Re: On-Going Services  
Riverwood Ranch Section 3 Final Plat and Construction Plans – 1<sup>st</sup> Submittal Review  
Angleton, Texas  
HDR Job No. 10361761

HDR Engineering, Inc. (HDR) has reviewed the construction plans and final plat for the above referenced subdivision and offers the following comments:

**SHEET 1 OF 2**

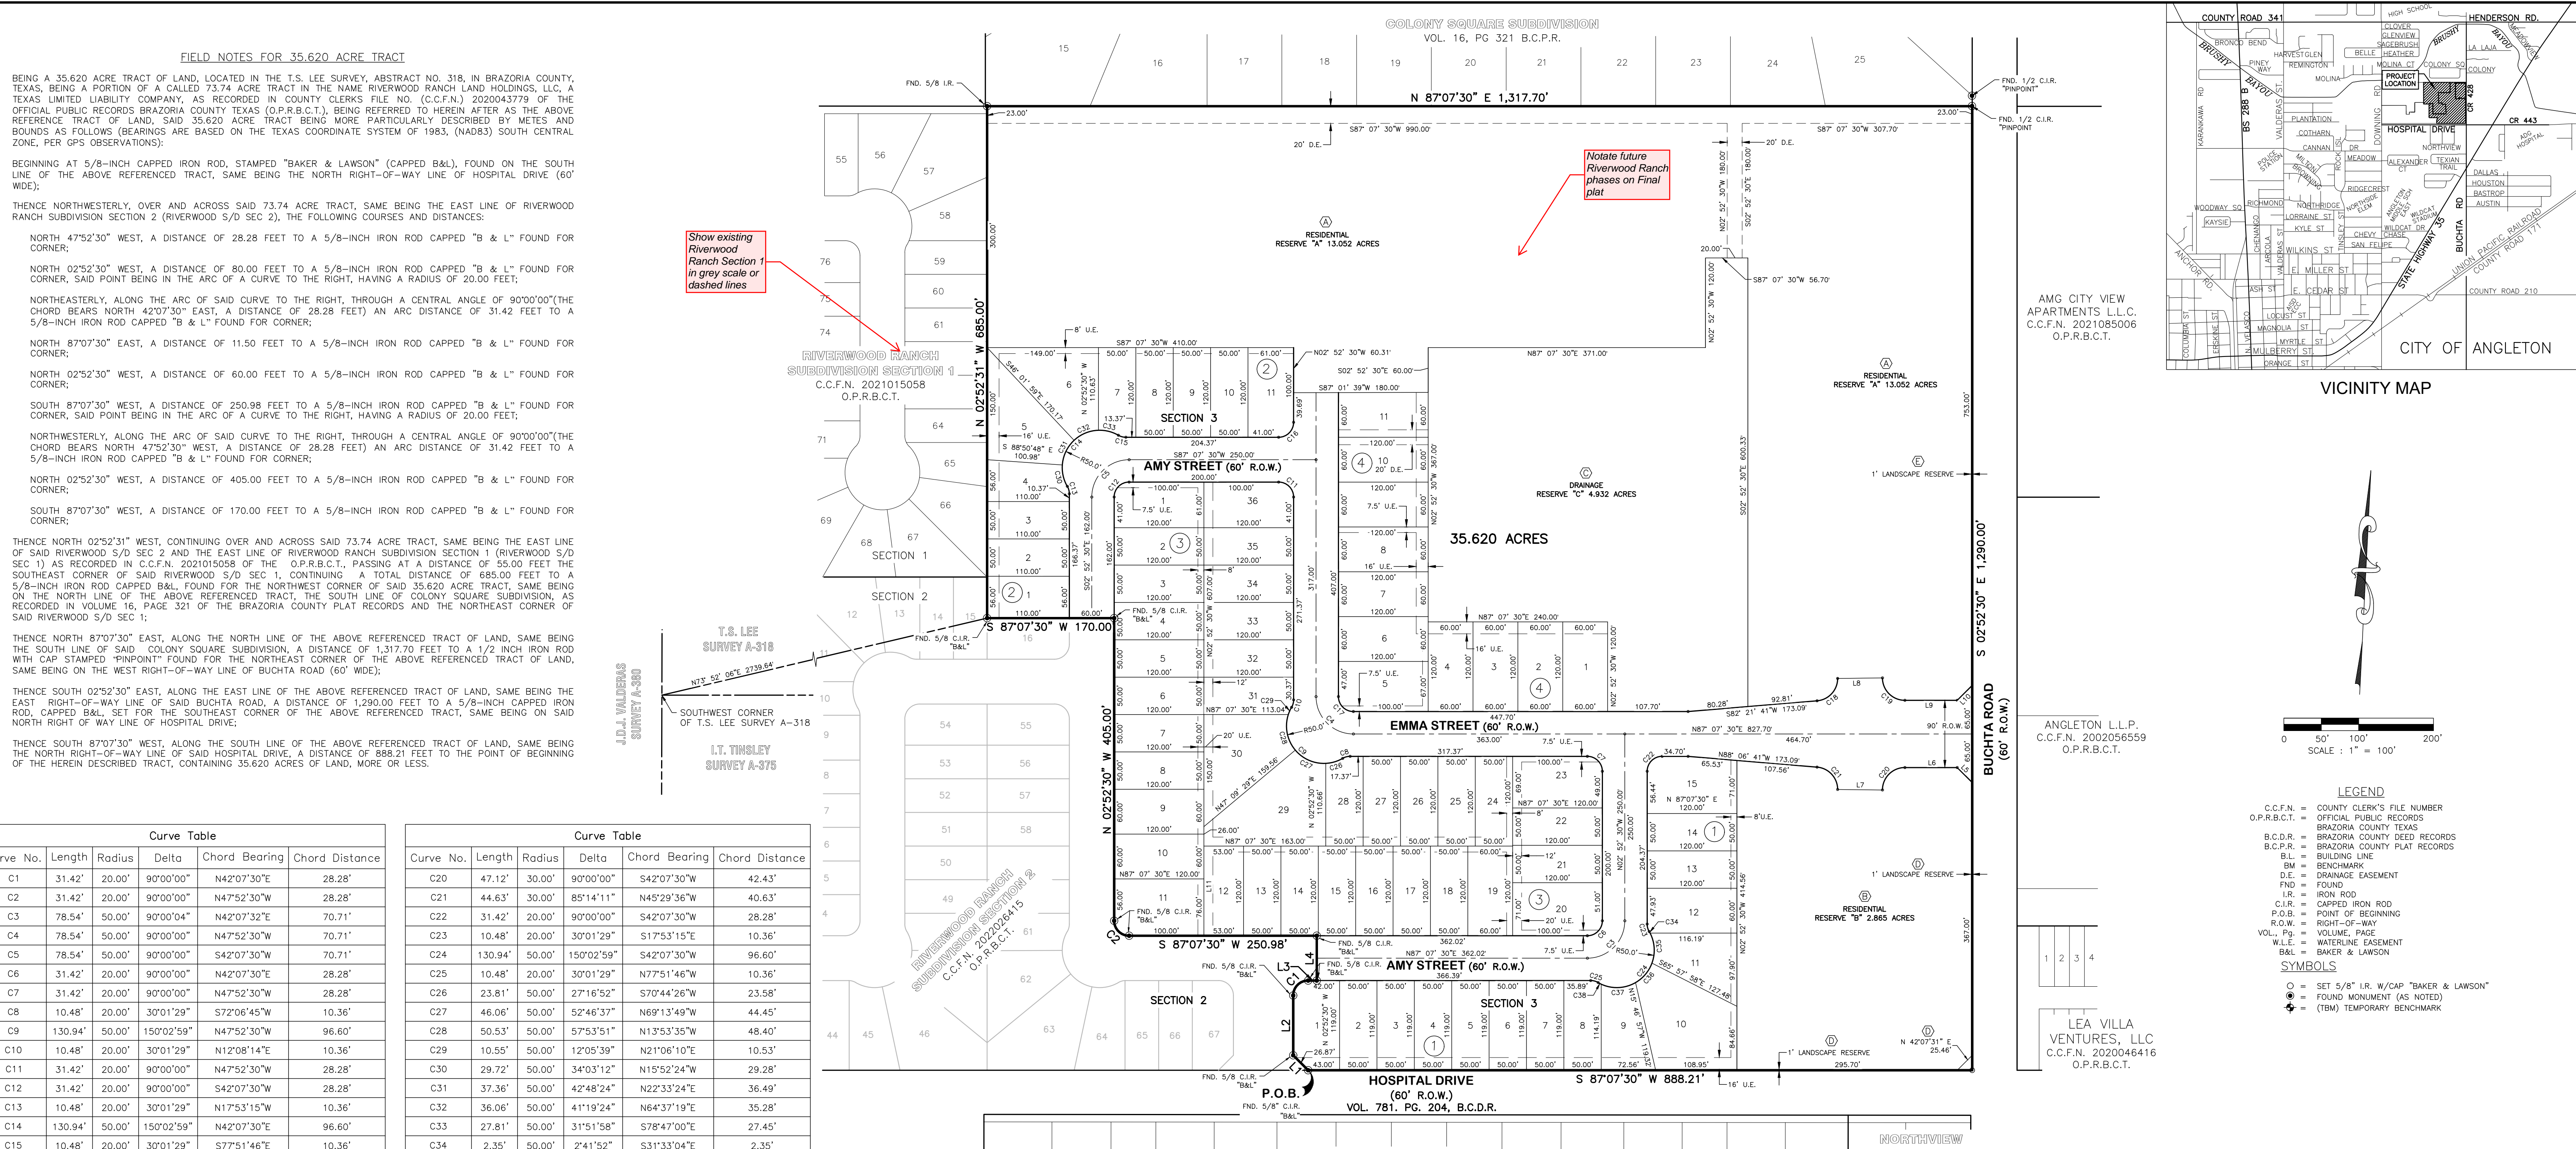
1. Show existing Riverwood Ranch Section 1 in grey scale or dashed lines.
2. Notate future Riverwood Ranch phases on Final plat.
3. Show existing Northview Subdivision Section 1 in grey scale or dashed lines.

PLAN & PROFILE  
 EMMA STREET  
 STA. 10+00 TO 15+60

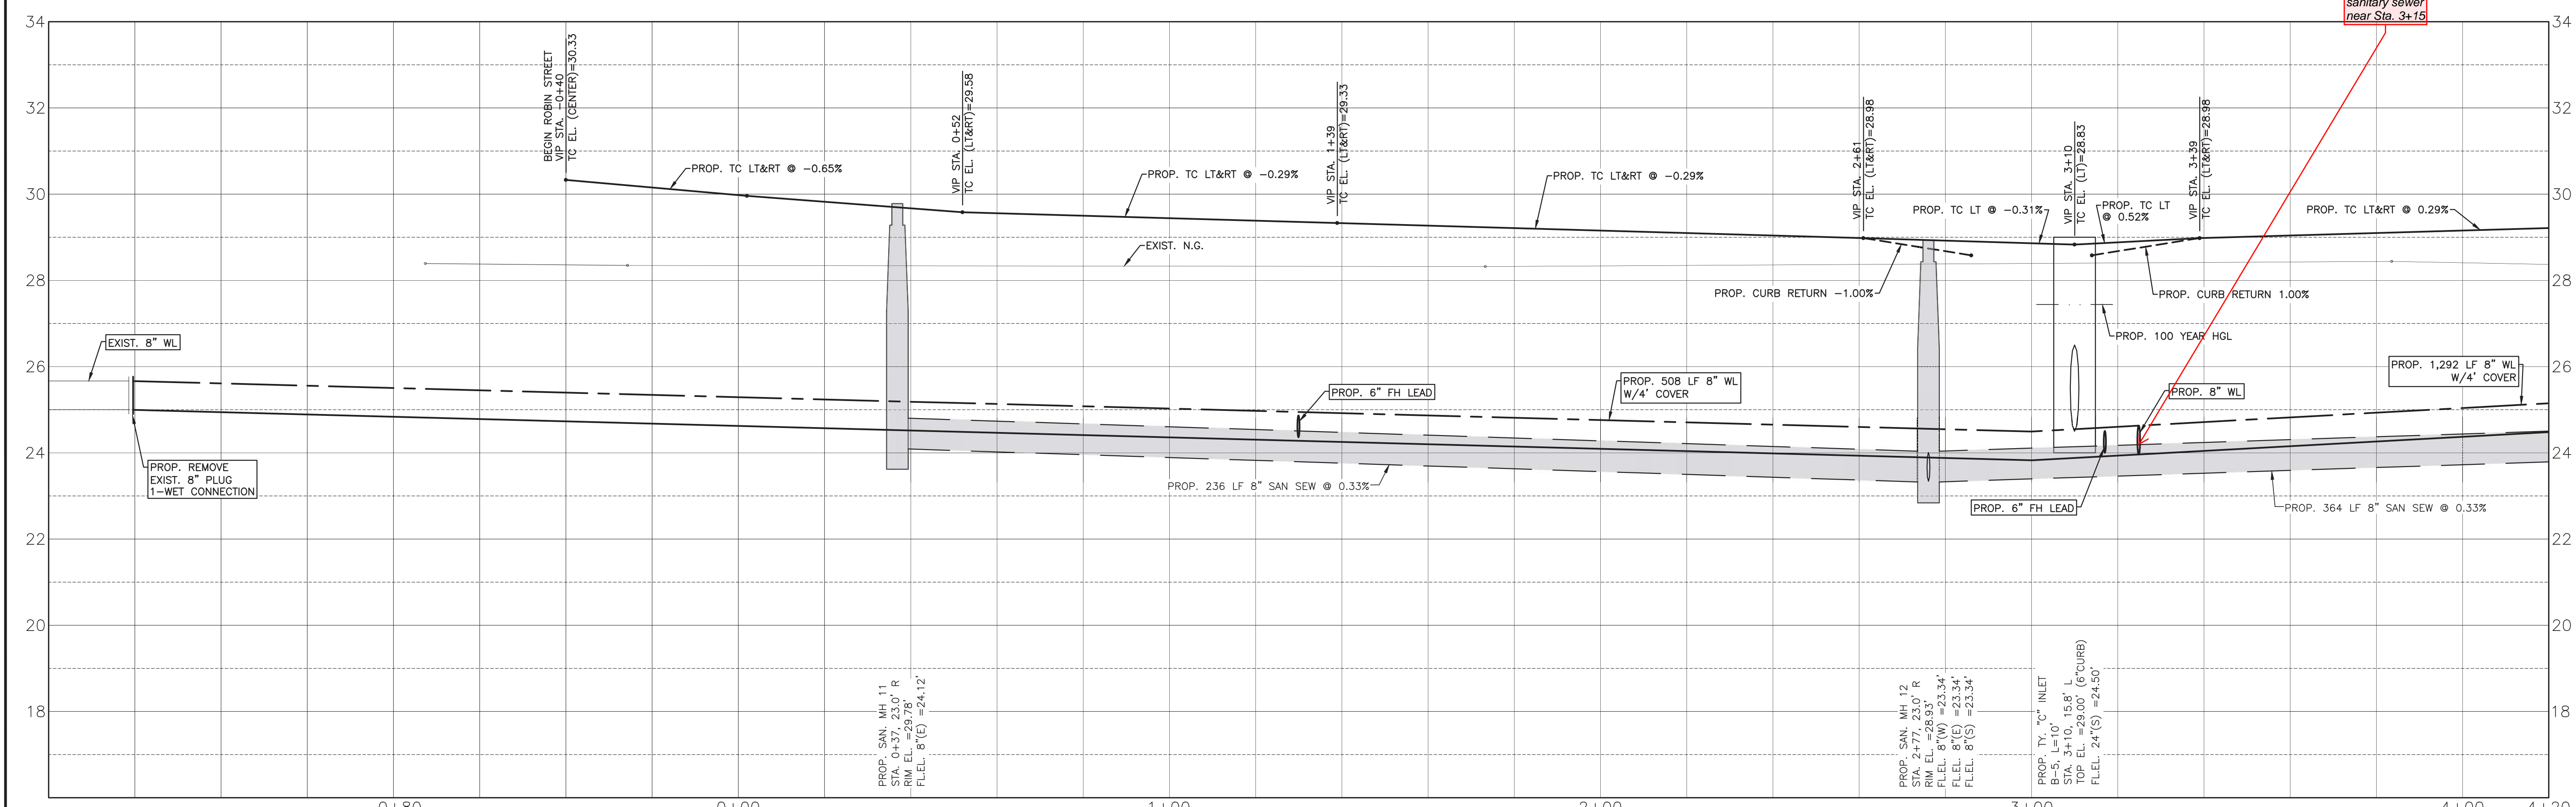
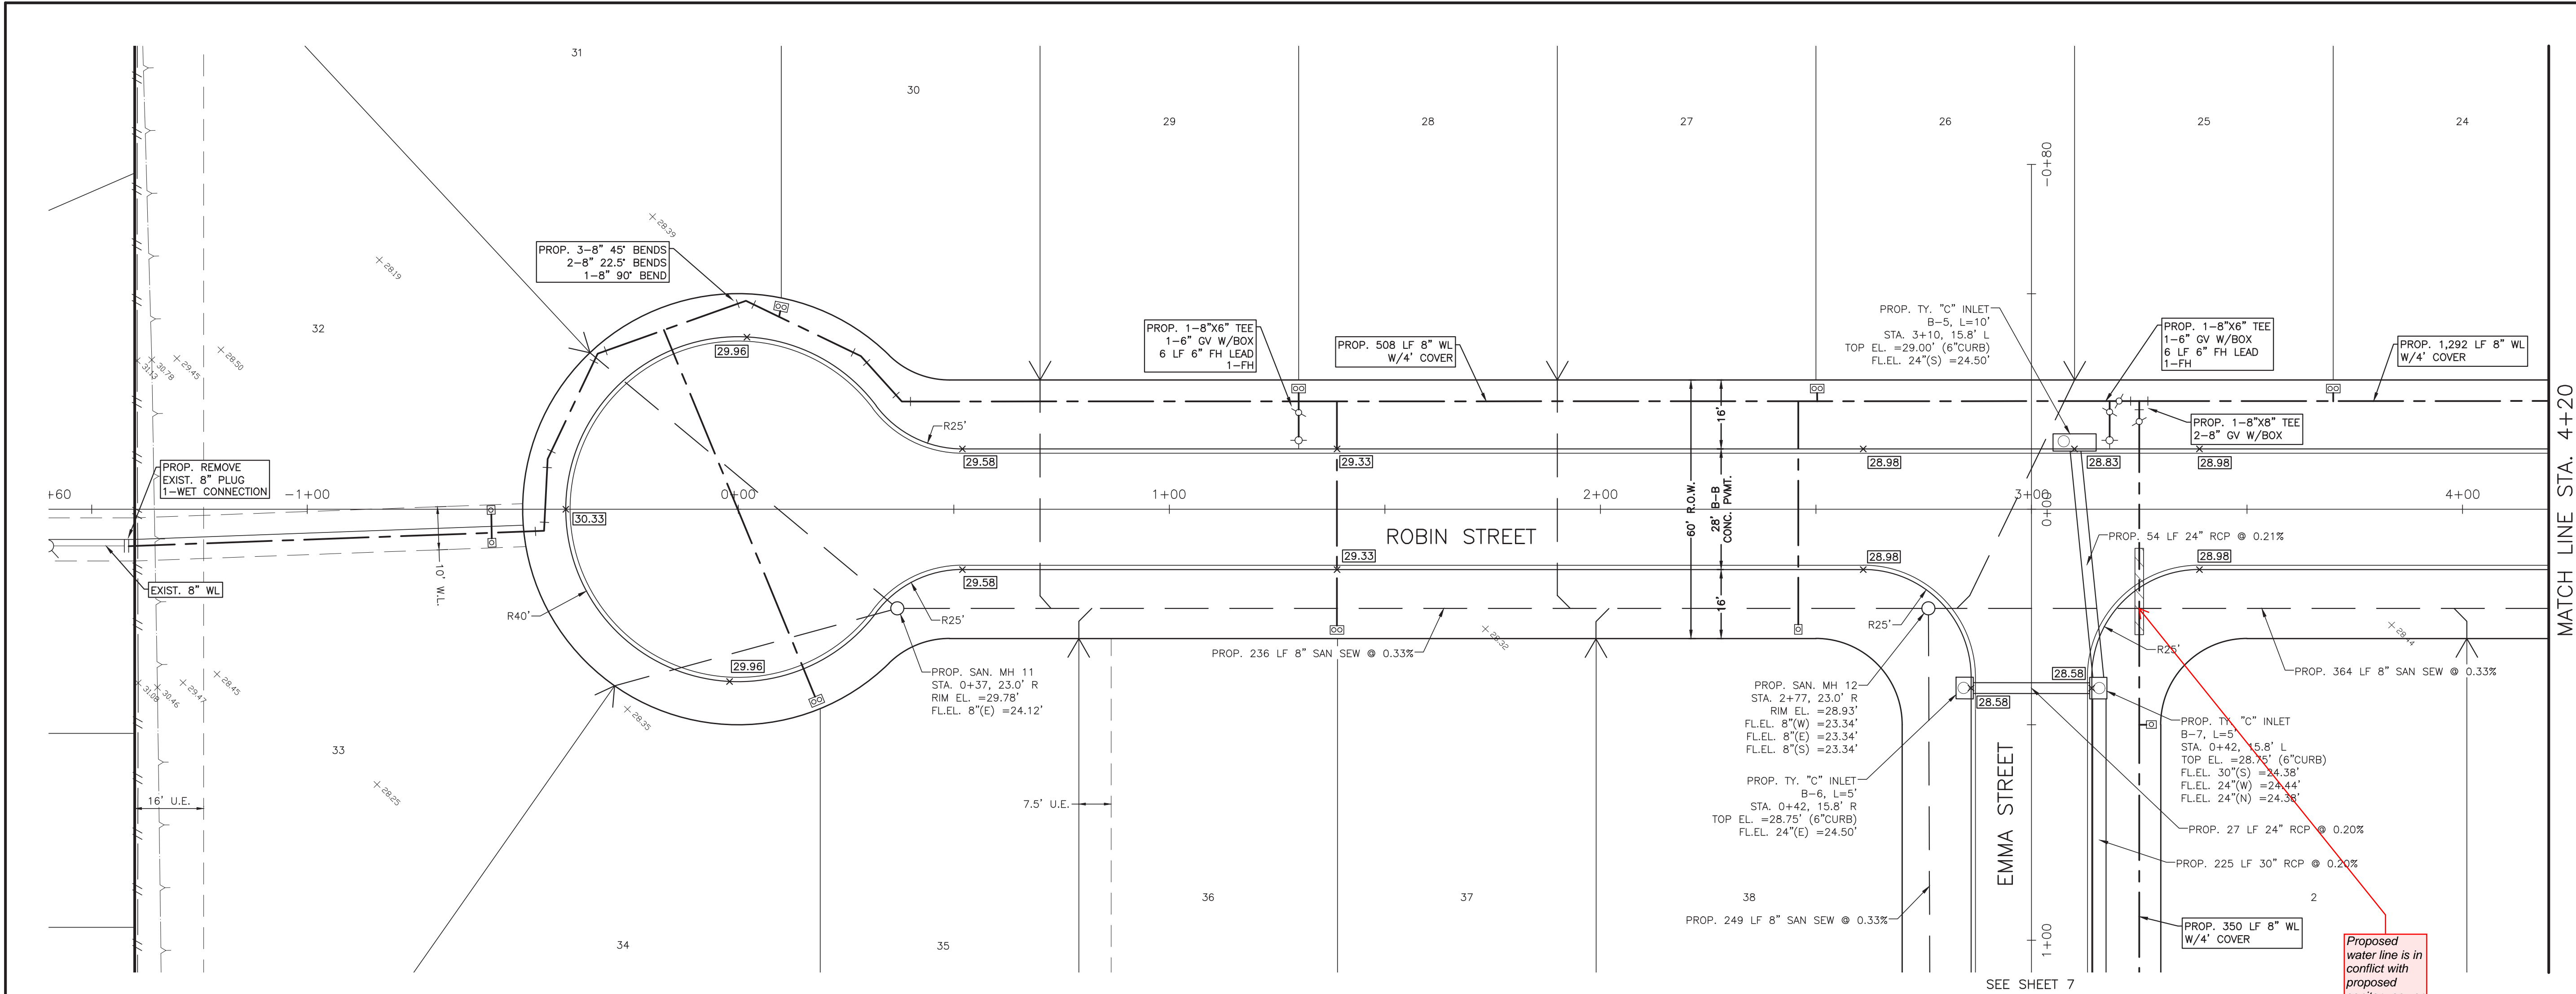
1. Verify if overflow weir to extend into ROW where notated on the plans.
2. Revise water line offset (Sta. 14+00) shown to be more gradual deflection. Example shown on profile.
